STAFF REPORT: 9/13/2023 REGULAR MEETING

APPLICATION NUMBER: HDC2023-00023

ADDRESS: 13320 BROADSTREET

SCOPE: REBUILD EXTERIOR OF HOUSE AND GARAGE (WORK COMPLETED WITHOUT APPROVAL)

Site Photo 1, by Staff October 19, 2023: (West) Front elevation showing replaced roof, removed chimney, removed arched doorway, bay windows, siding, porch, and other features, and introducing new window in the gable without approval.

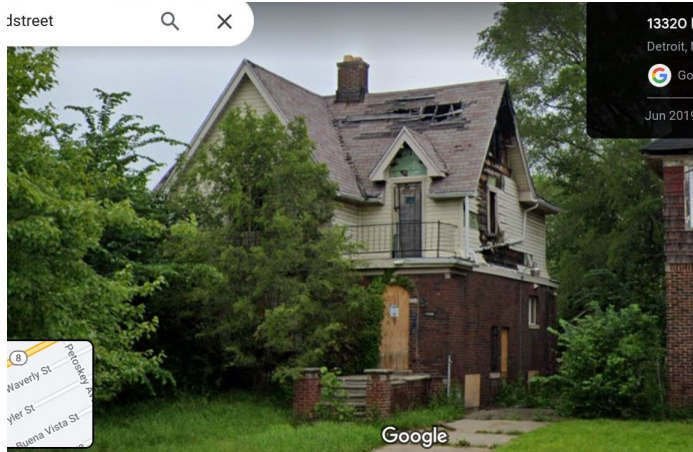
- The removal of the newly installed attic window at the front façade's gable is appropriate, in staff's opinion to restore front façade's historic, character-defining features.

- The proposal to install a picture window at the garage's front facing gable, is not appropriate in staff's opinion. This introduces a new feature that was not historically present and reduces the relationship of garage to the main house, which also has no window in its front facing gable.

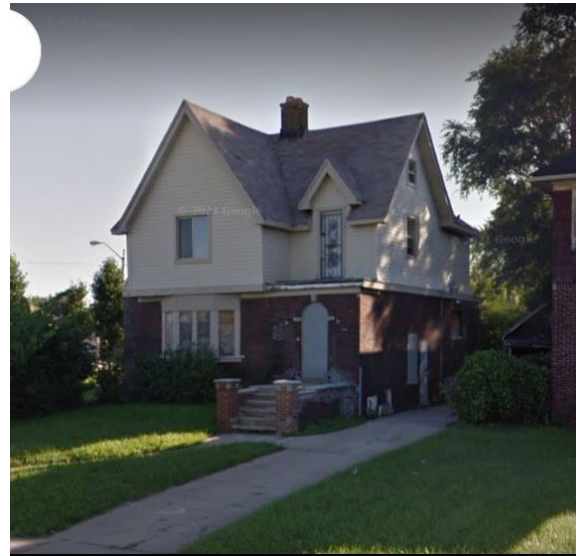
- The bay windows historically had 4 casements with divided lights, not 3 double-hung windows with no divided lights as proposed here. Staff considers the bay windows, the 4 casements with divided lights as a historic, character defining feature that is still missing in this proposal's attempt to restore the dismantled bay windows.

- The proposal to install a single double-hung aluminum-clad wood window at the second-floor front façade to recover the lost original wood window is appropriate. However, the 1/1 configuration does not match the 8/8 true-divided light as shown in the historic designation slide. Also, the installation of polypropylene shutters instead of wood shutters is not appropriate.
